DEVELOPMENT REVIEW BOARD
SUPPLEMENTAL SUBMITTAL

PROJECT NO. PR-2021-005371
Application No. SD-2021-00186

SUBMITTAL DESCRIPTION: Plat revised to add ZHE variance information and modified DRB decision note for sidewalk and right-of-way widths. Letter to DRB modified to address the same and to correct the incorrect addressing.

Re: Final Plat Review for Proposed Lots 5-A and 6-A, Ute Addition

**Plat for
Lot 5-A and 6-A,
Ute Addition
Being Comprised of
Lots 5 and 6, Ute Addition
City of Albuquerque
Bernalillo County, New Mexico
April 2021**

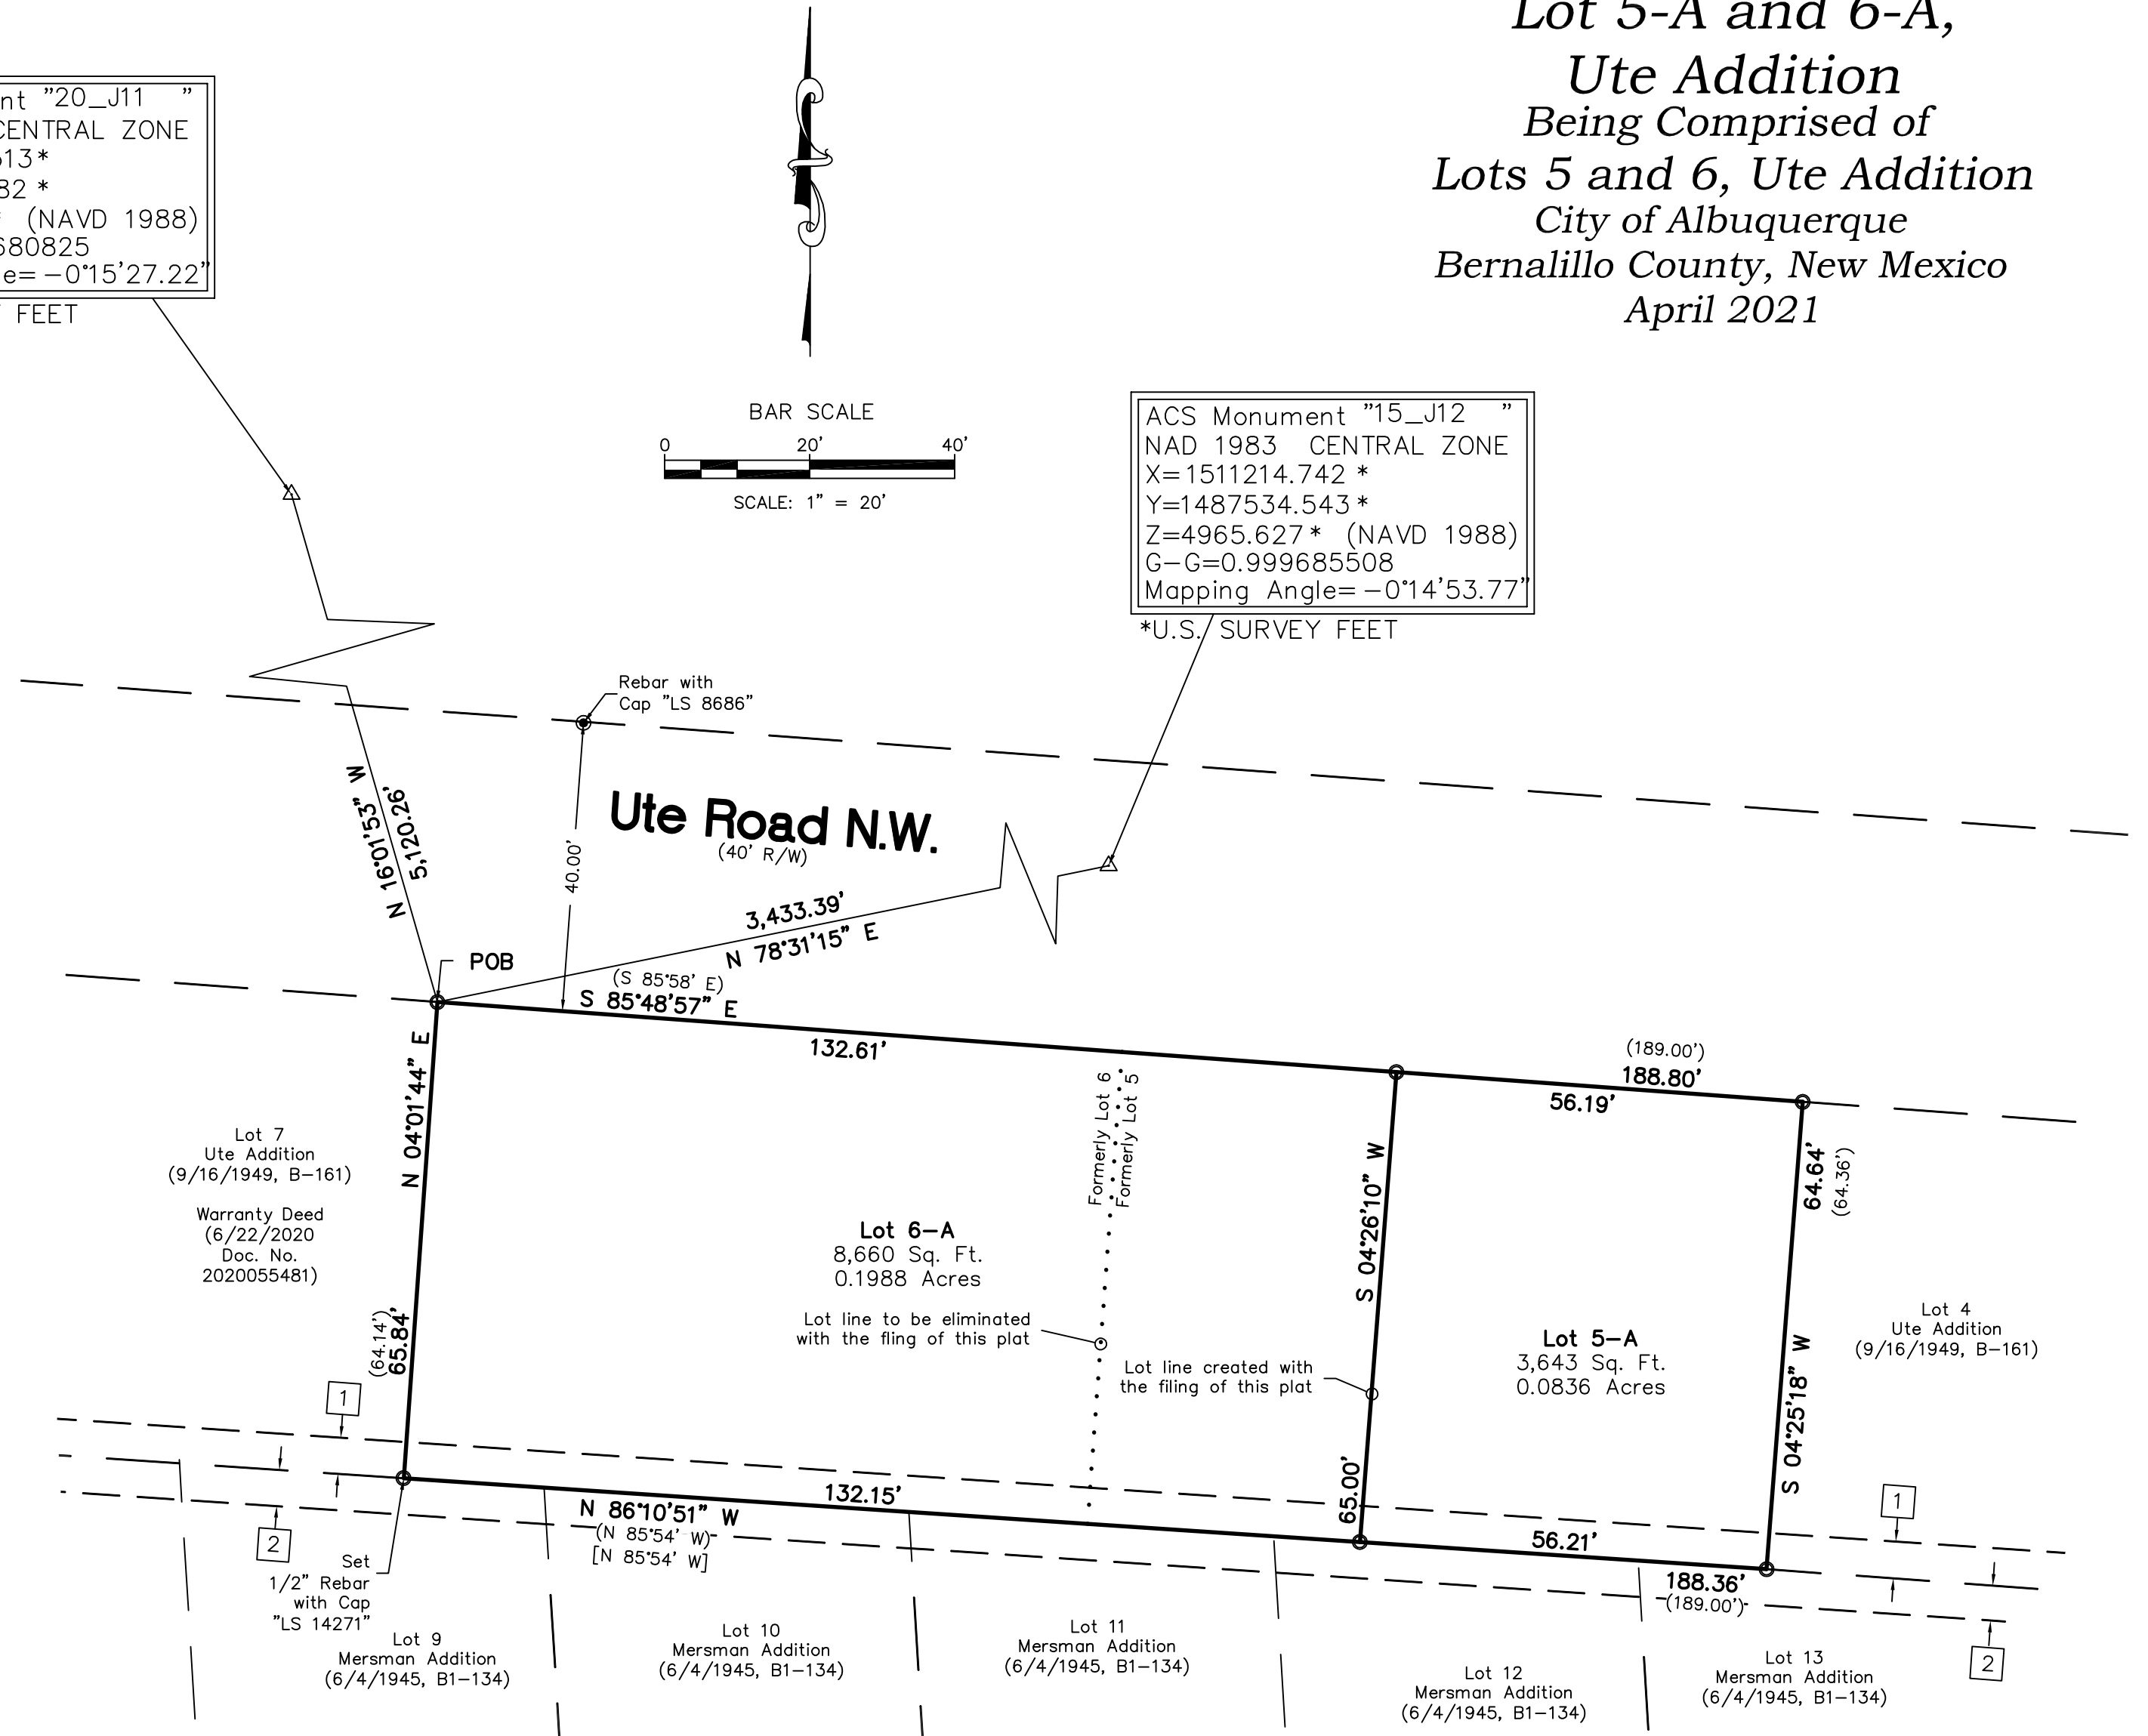
Add note to plat that a ZHE variance was granted for lot size.

Add note to plat that a ZHE variance was granted for setback.

Add notes to the plat that Staff determinations were made to allow existing sidewalk width of ROW width for Ute Road on plat.

Noted, ZHE variance was discussed at 9/15 hearing and noted on page 2 of the plat.

Noted, the ZHE variance and staff determination notes have been added to page 2 of the plat.

**Site Sketch for
Lot 5-A and 6-A,
Ute Addition
Being Comprised of
Lots 5 and 6, Ute Addition
City of Albuquerque
Bernalillo County, New Mexico
August 2021**

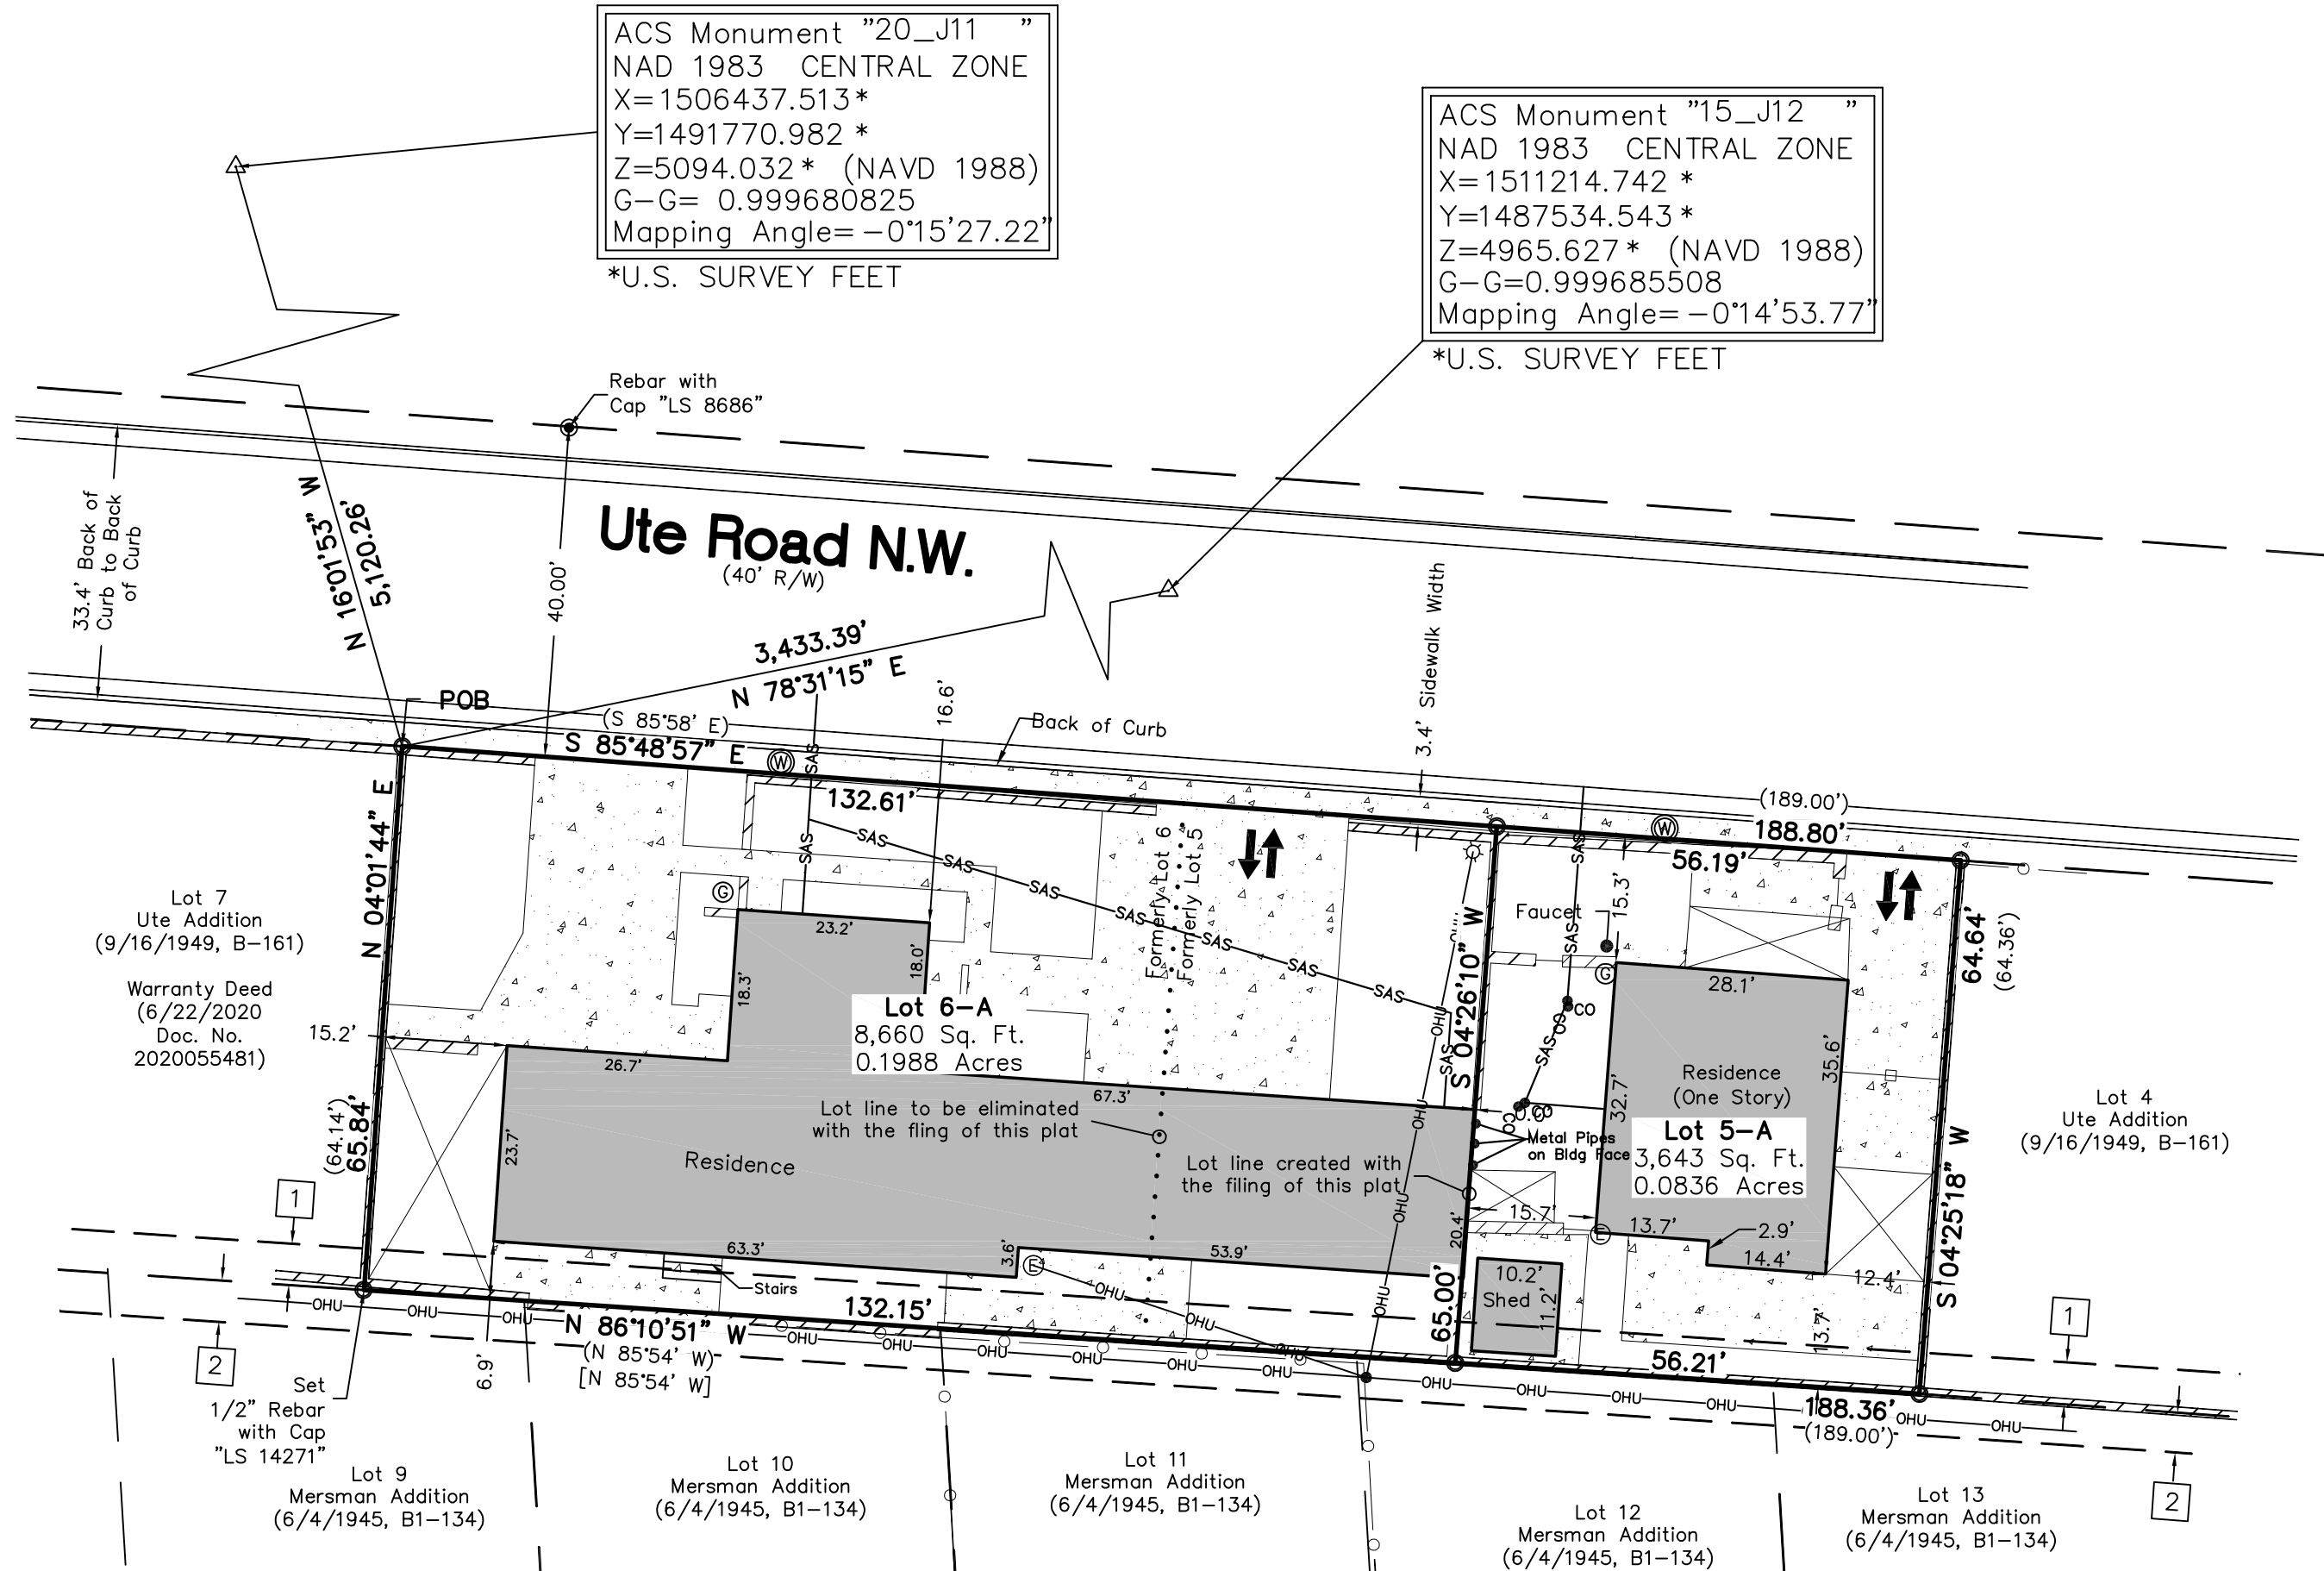
2. The walls along the front of the property line appear to fall within the sight distance triangles. Wall height should not be higher than 3 feet from the gutter. Modification of the wall is necessary prior to sign-off. (I do not see any additional information on these walls within the latest submittal package.)

Noted, the walls along the front of the Lot 6-A property are not out of compliance for the western driveway, but the walls for the driveway along the former lot line are out of compliance with sight triangle requirements by less than a foot. The walls for Lot 5-A are out of compliance by approximately a foot and a half.
